Addendum #2

Project: 2024 – Fishers Elementary School Addition & Renovations

ADDENDUM NO: 2

PROJECT: 2024 – Fishers Elementary School Addition and Renovations

DRAWING NUMBER A614

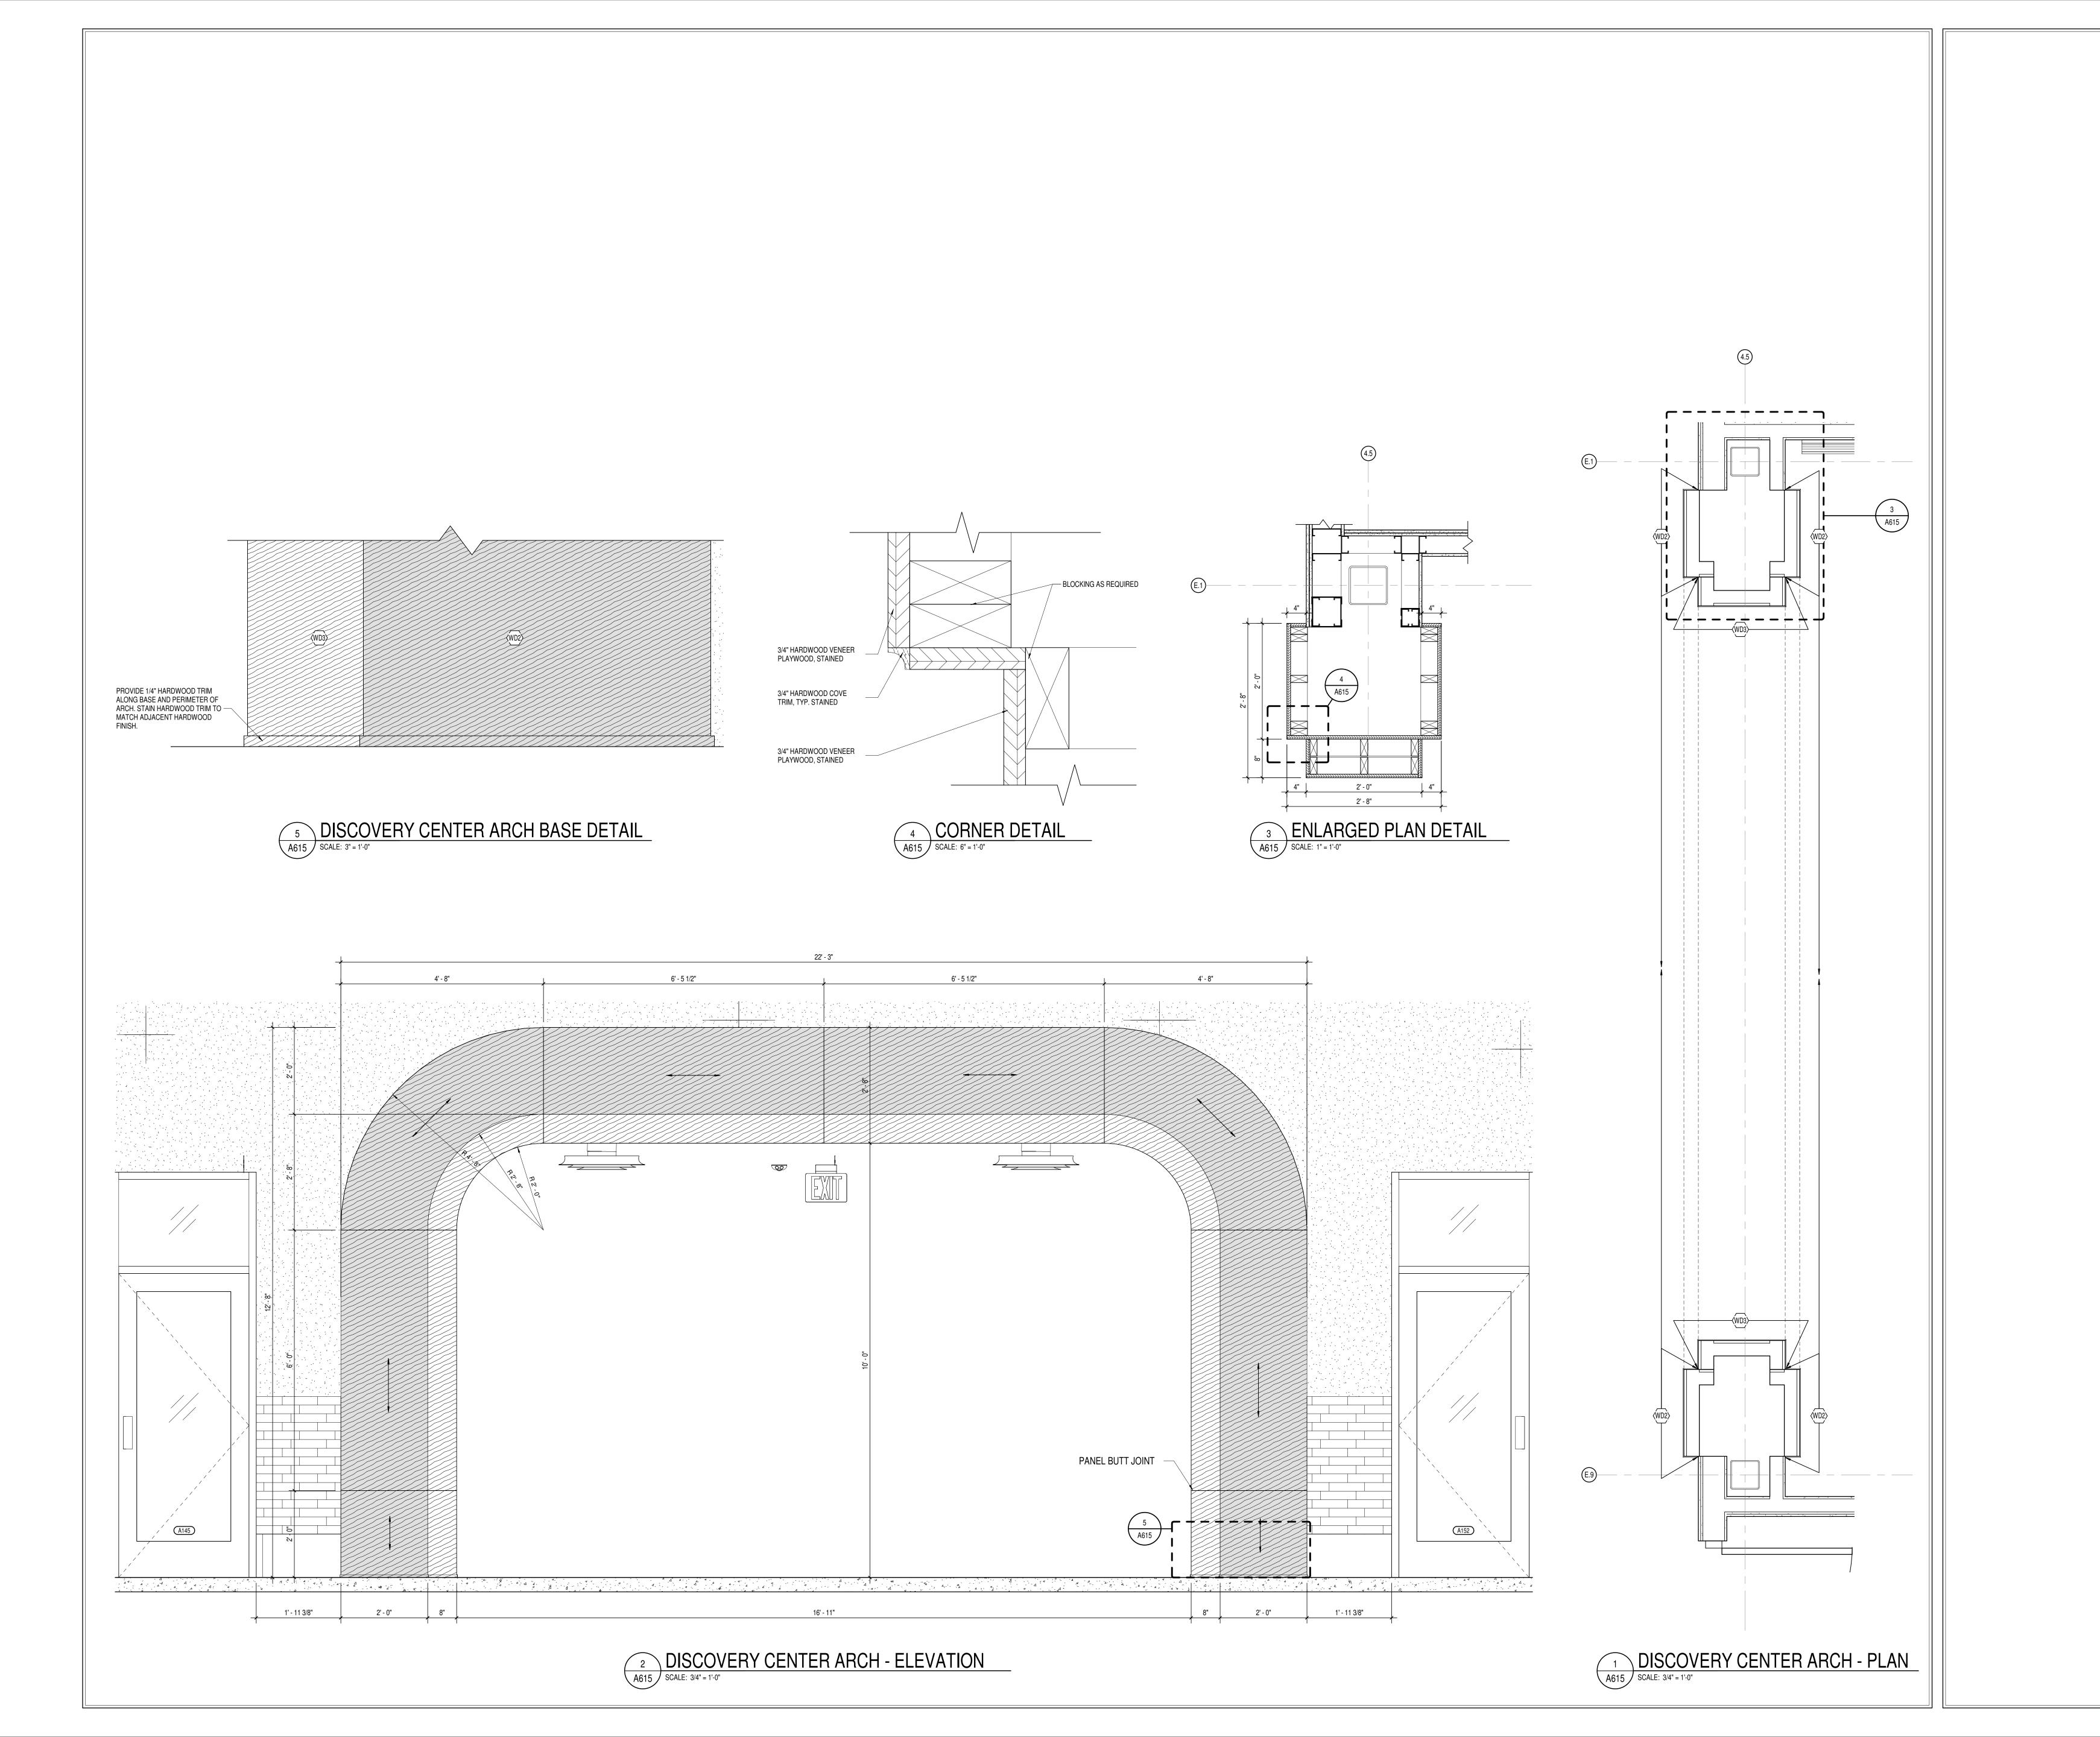
- A. Removed finish tags for clarification
- 4.23 A614 INTERIOR ELEVATIONS CAFETERIA
  - A. Revised tile scope on 4/A614

DRAWING NUMBER A801A PROJECT NUMBER 2021119

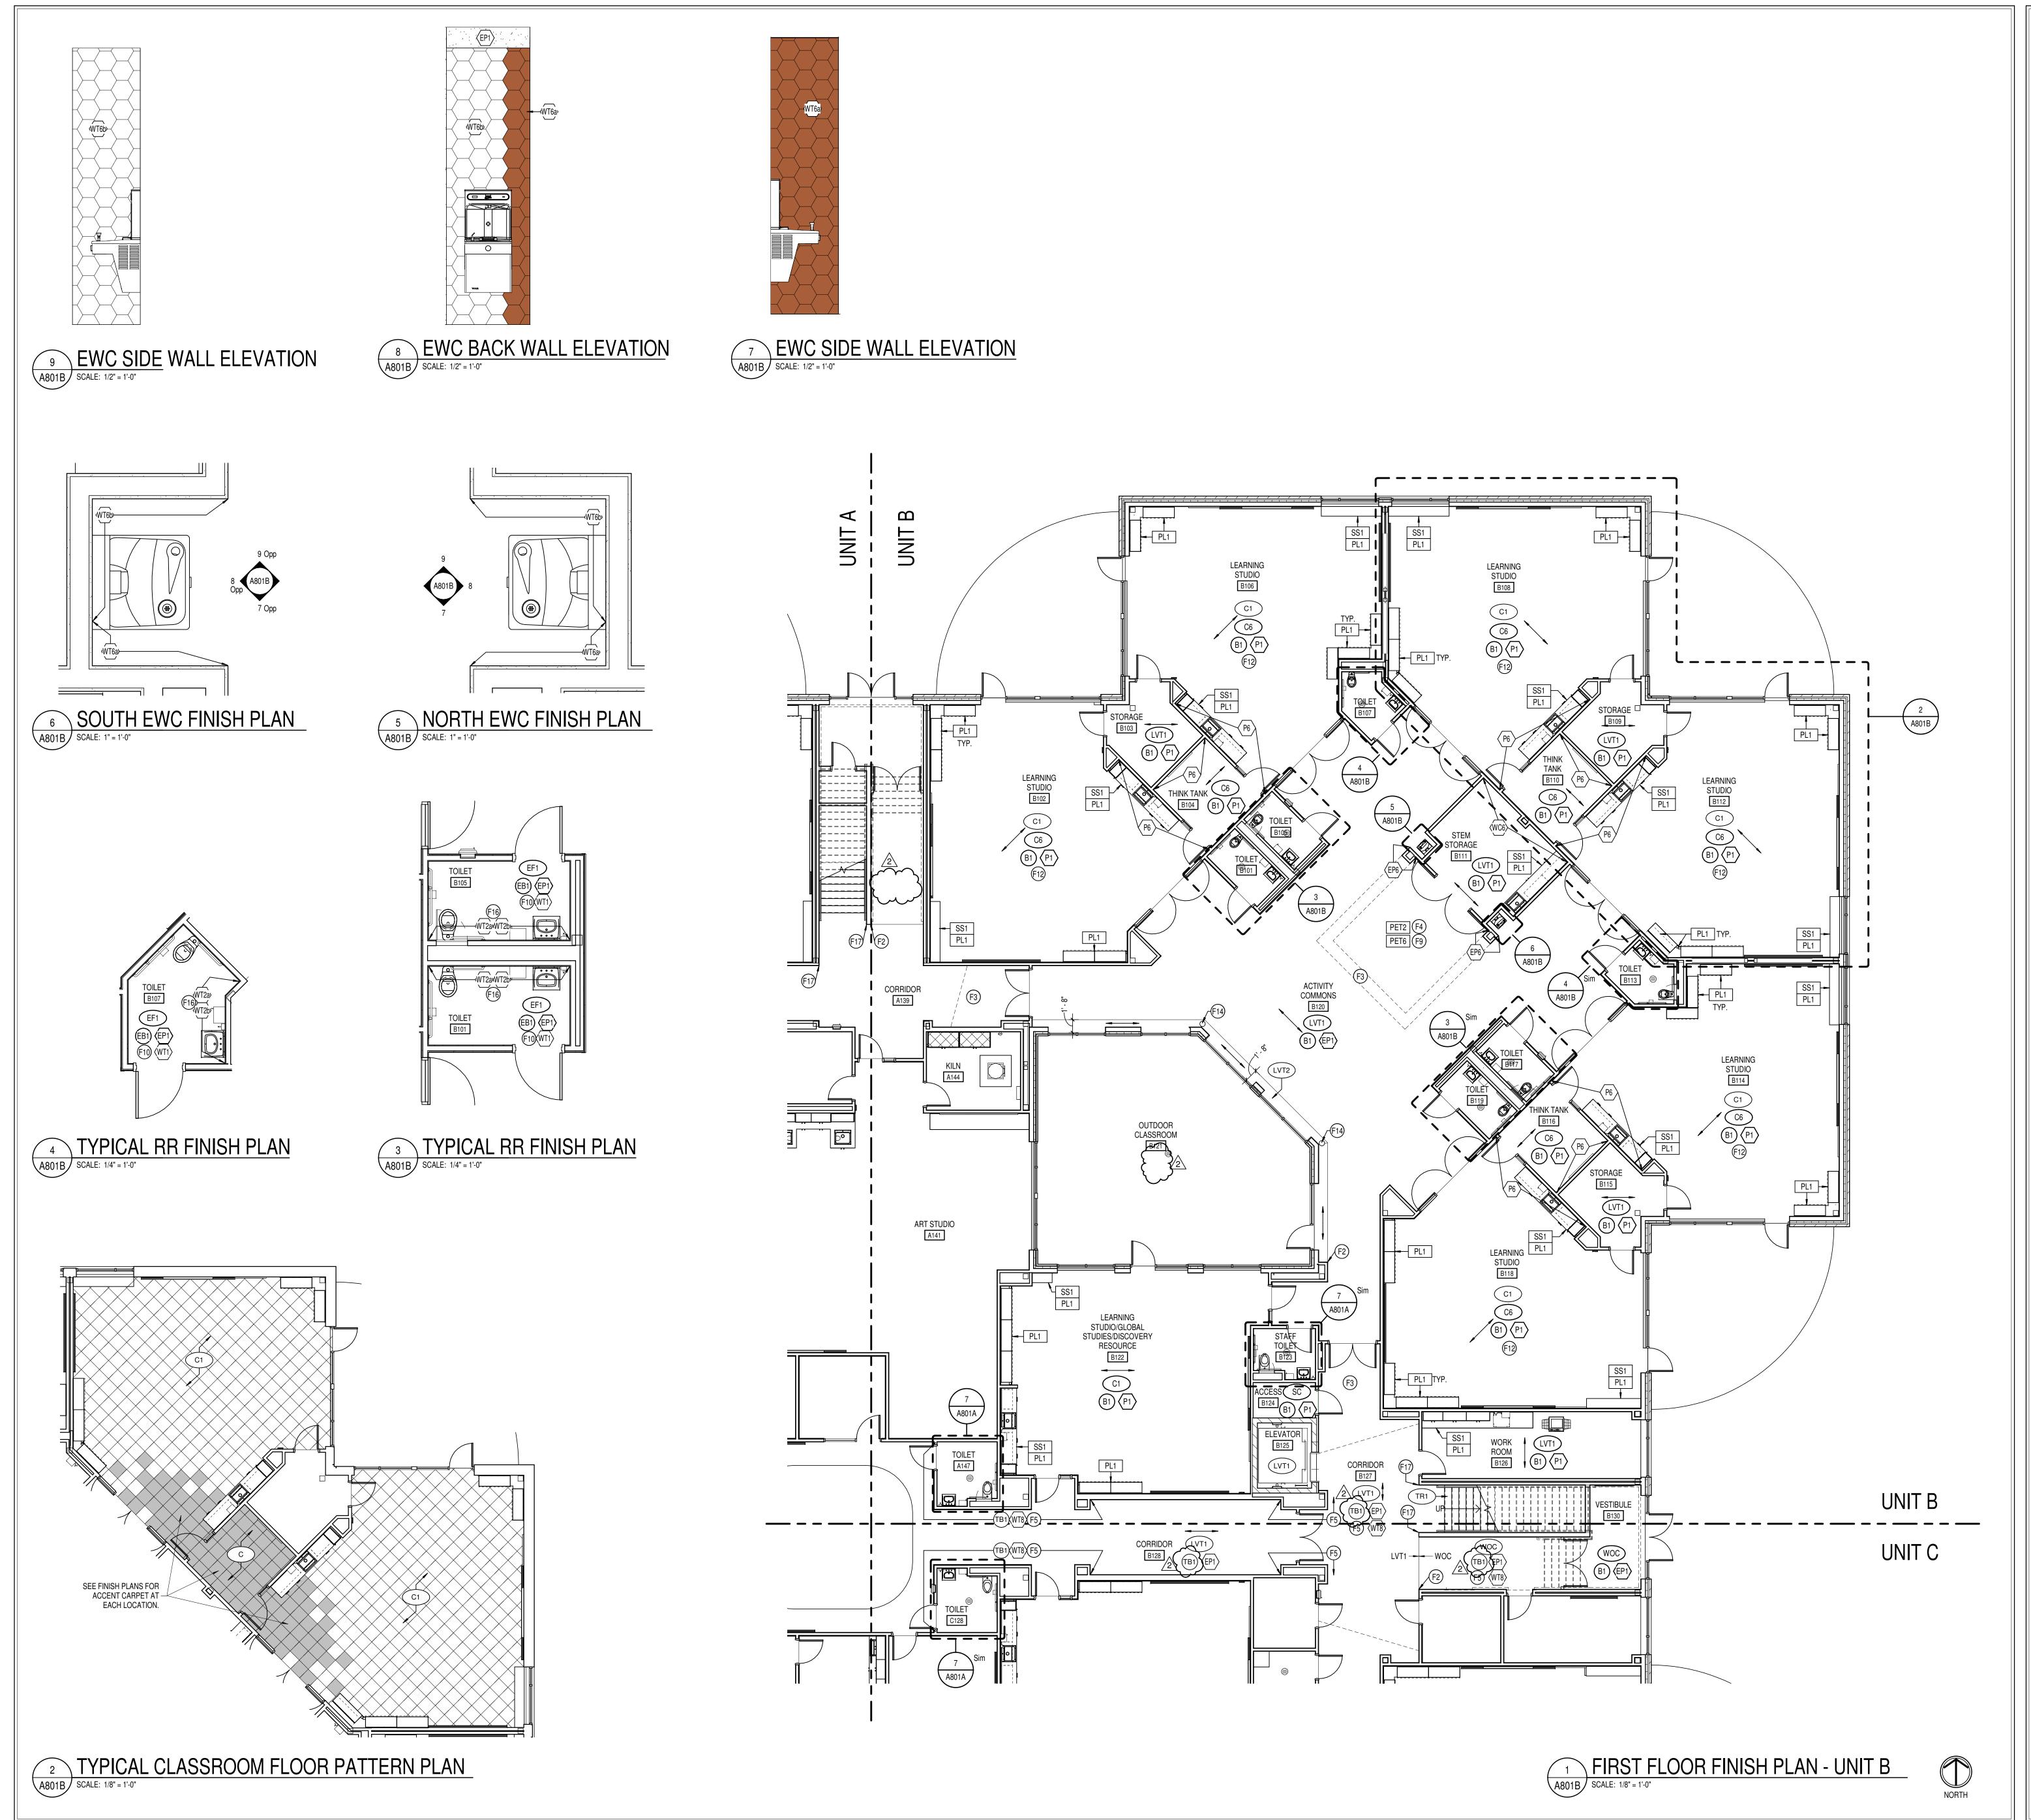
- A. Removed tags for clarity
- B. Revised TB base tags to TB1
- C. Revised RB1 to TB1 in CORRIDOR A139

A801C PROJECT NUMBER 2021119

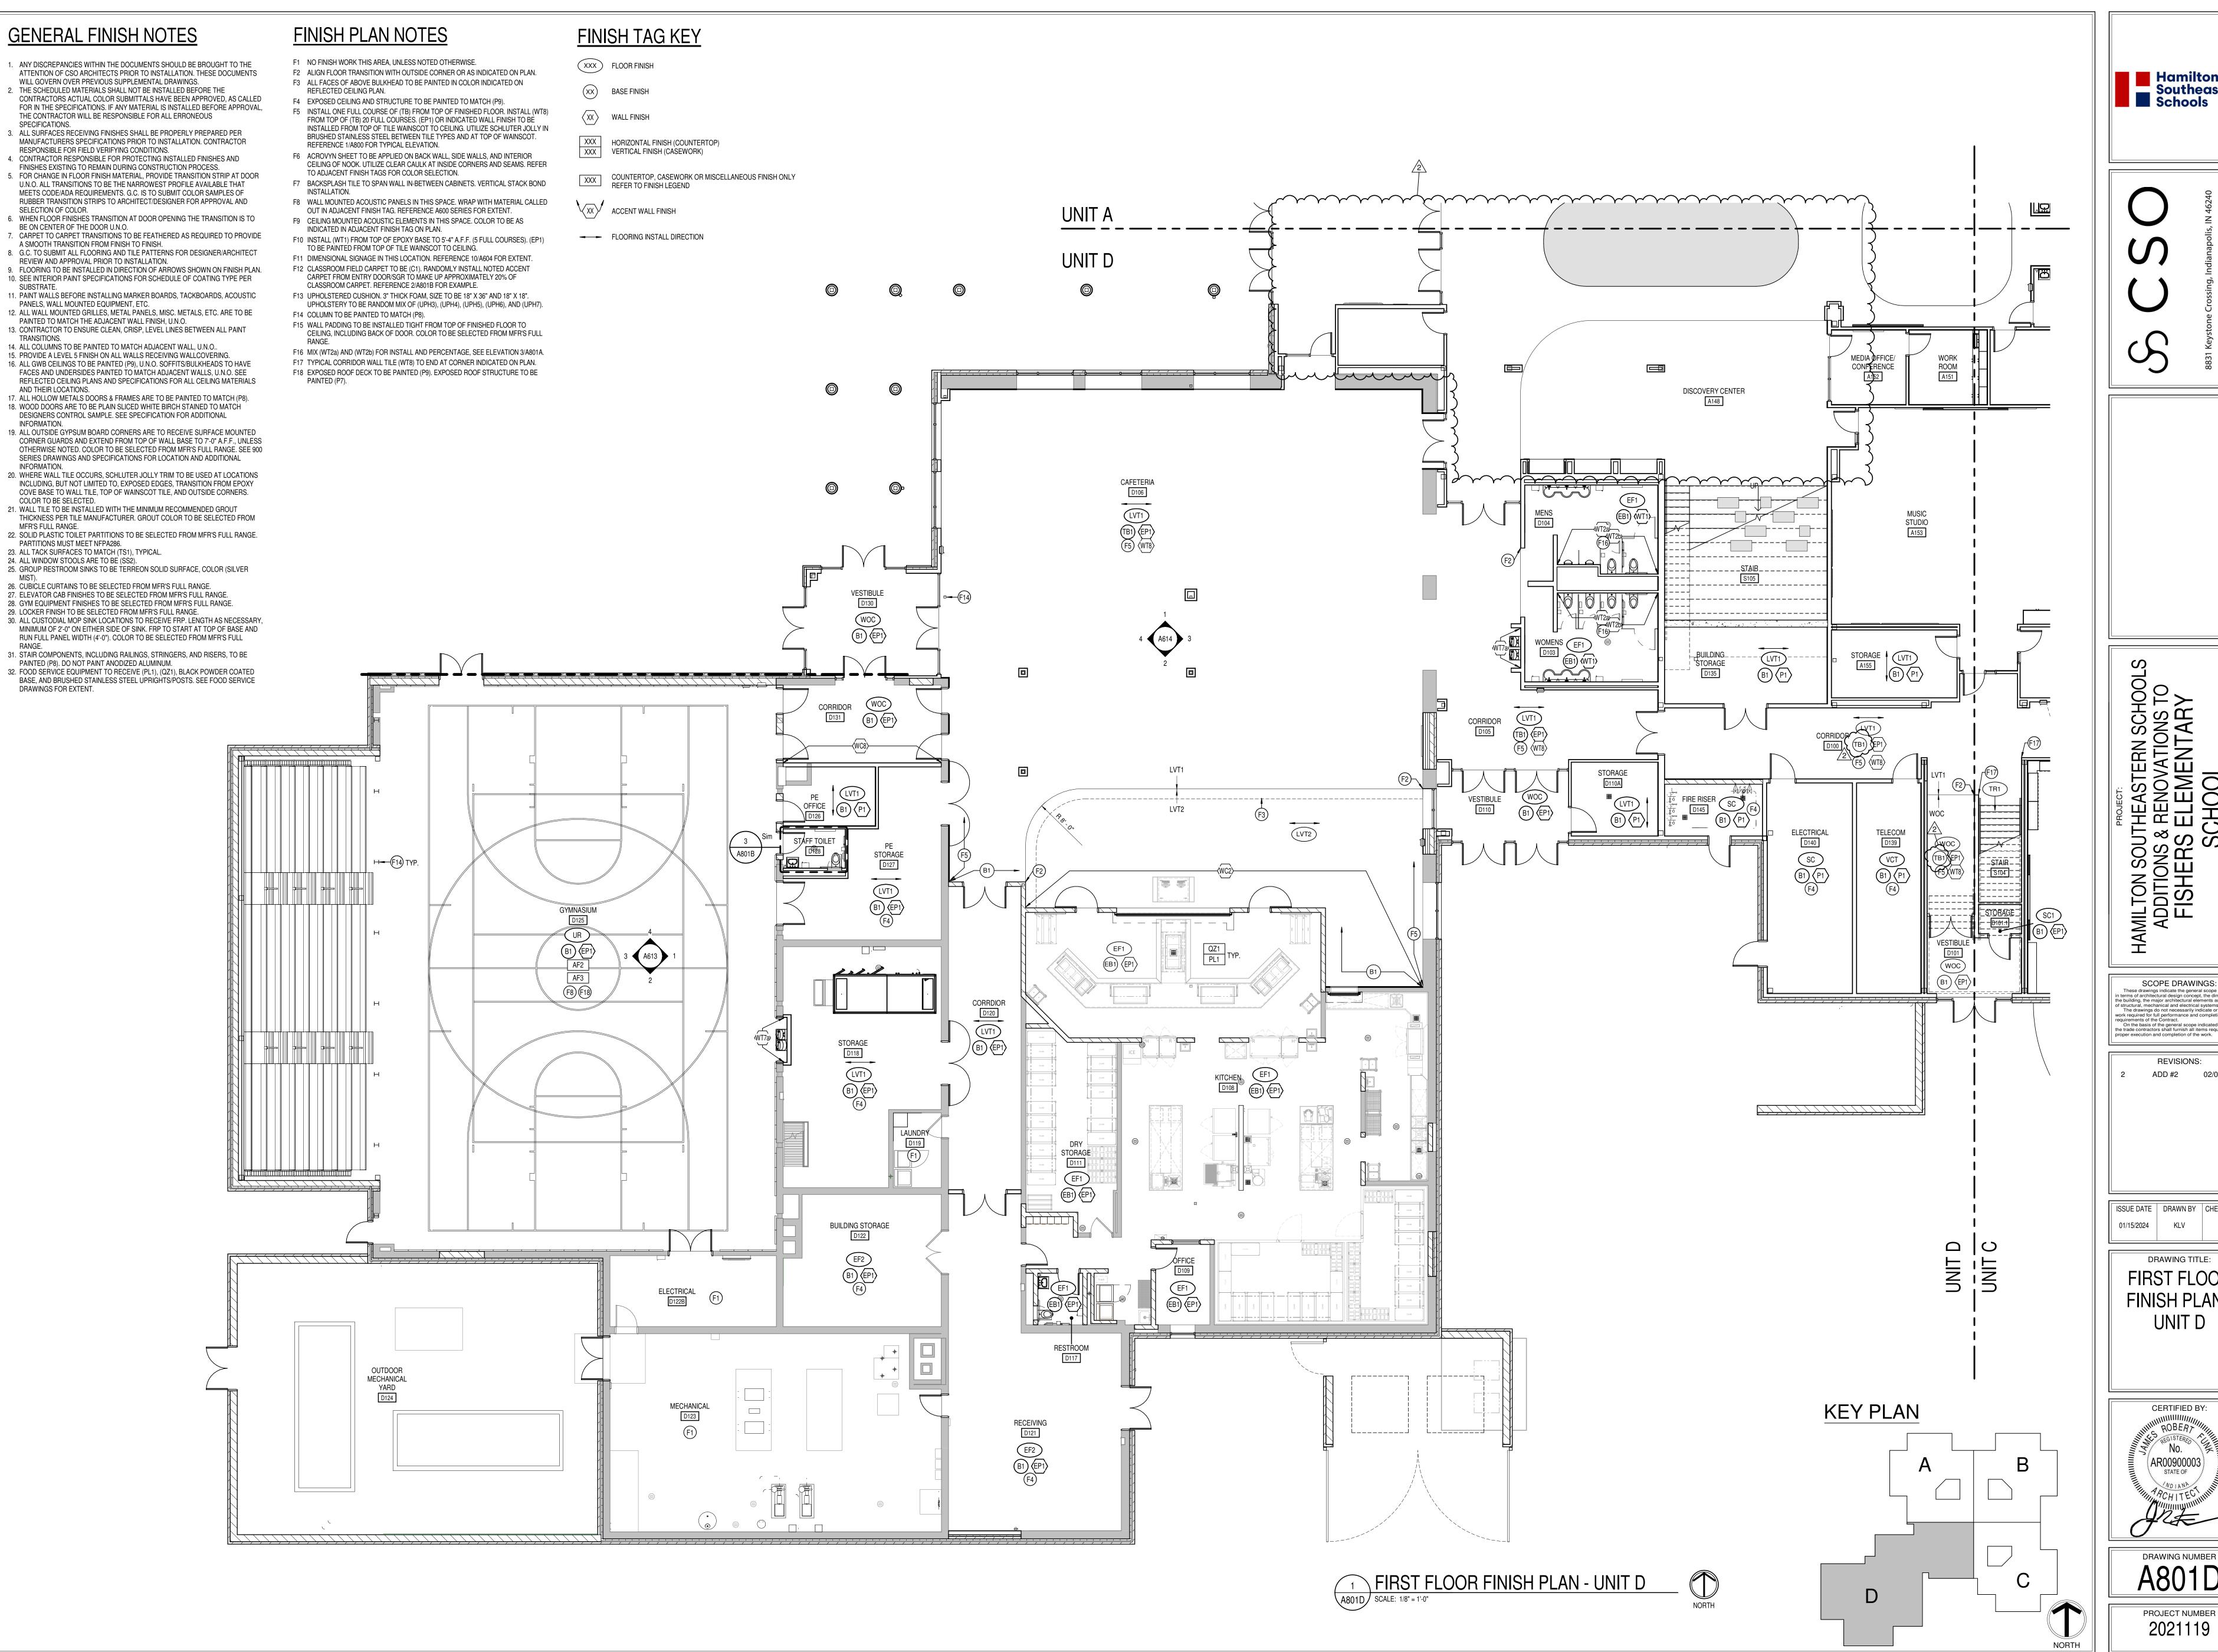
- A. Removed tags and shifted callout tags for clarity
- B. Added Elevation tag to 2/A801C
